April 18, 2016

Public Works Facility

Jefferson County

ADDENDUM #3

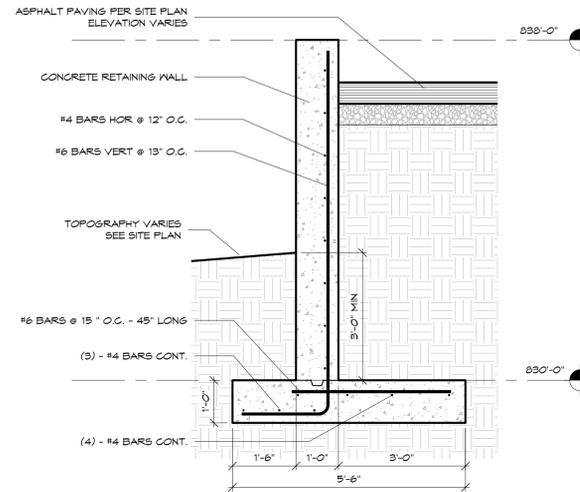
18. Q: On sheet A201 what are you looking for with note #3 overhead door opener 1,2,3,4.

A. The overhead door contractor to provide a push button station just inside door 105B to open the (4) four garage doors. This button is in addition to the (3) button stations at each door.

1. **Sheet A-102 – Lake Mills Site**

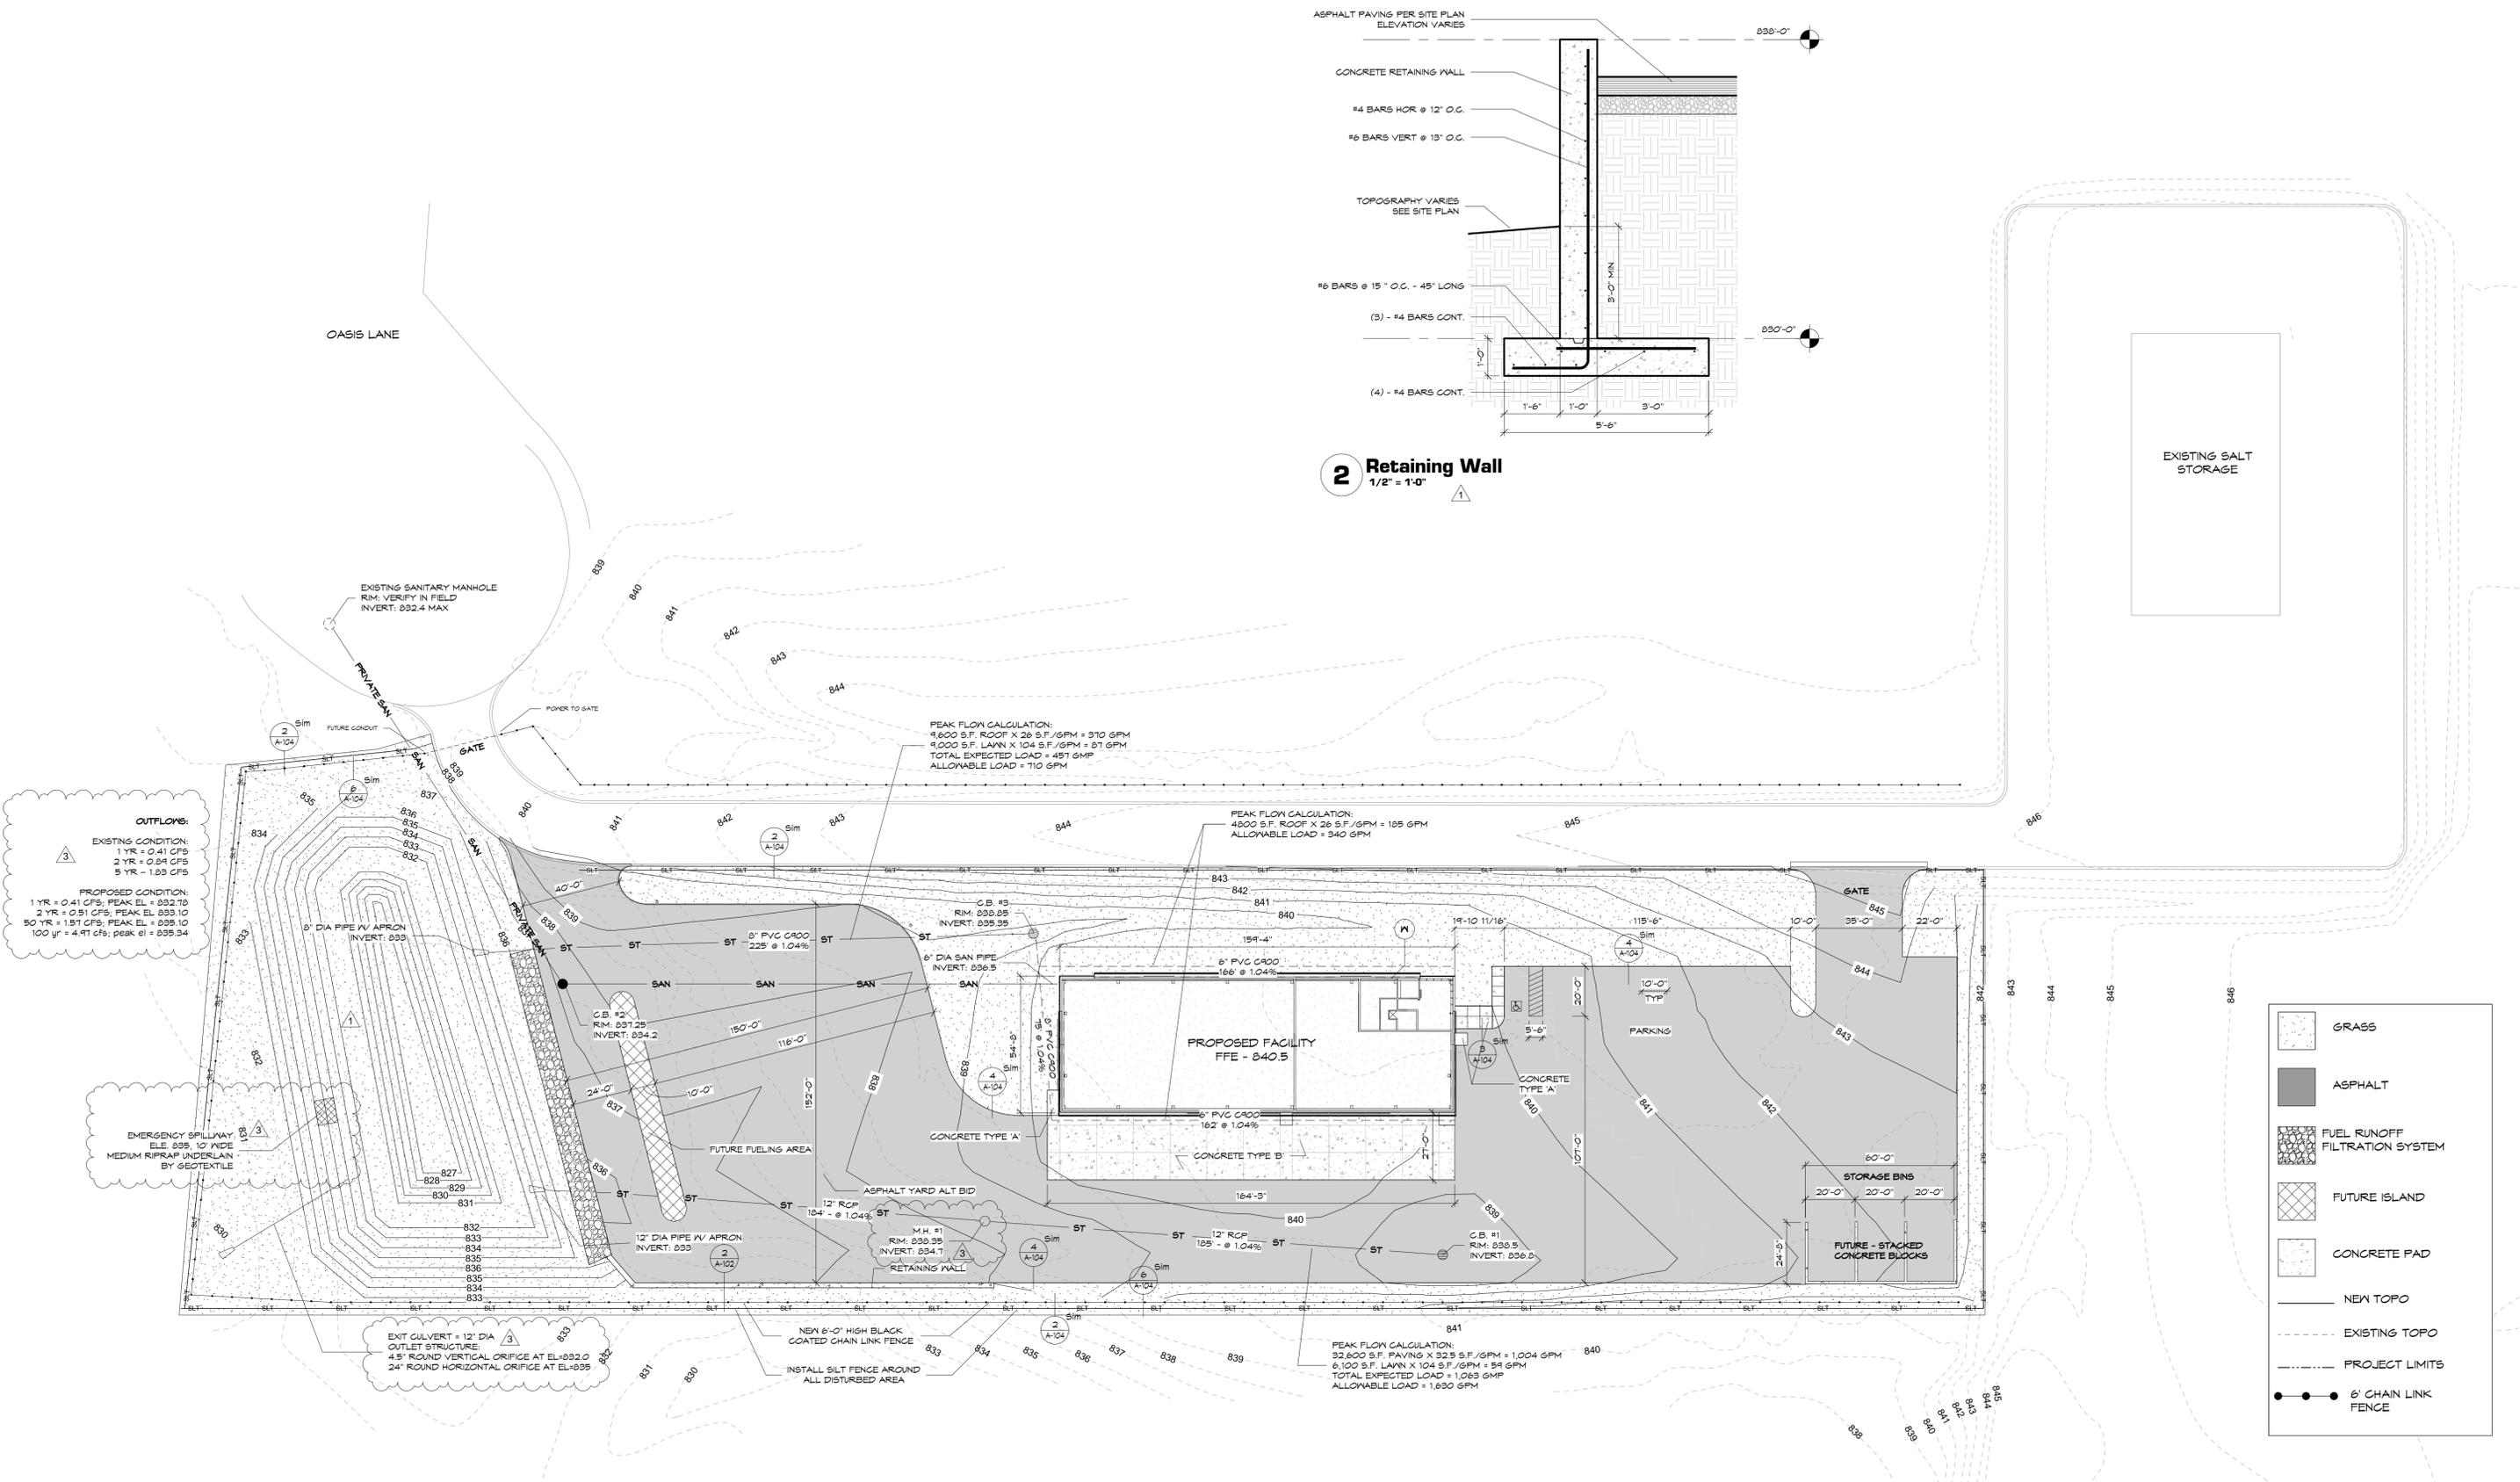
1. *Q: Please see snipping from drawing A-102 below and questions below for the Lake Mills site. There is a storm pipe, end section and storm structure shown on the northwest corner of the Lake Mills site. It appears that this pipe and structure represents the outlet for the pond. Please provide size, material and depths of the pipe and structure.*

- A. See Attached revised sheet.
2. *Q: The plumbing plans show a 1-1/4" water service pipe coming into the northeast corner of the building. This pipe is not shown on the A-102 plan sheet. It is understood that others will be installing the well, however, is the site utility contractor responsible for installing the 1-1/4" water service from the well to the building? If so, please provide additional information such as material, depth and length of pipe for this water service.*
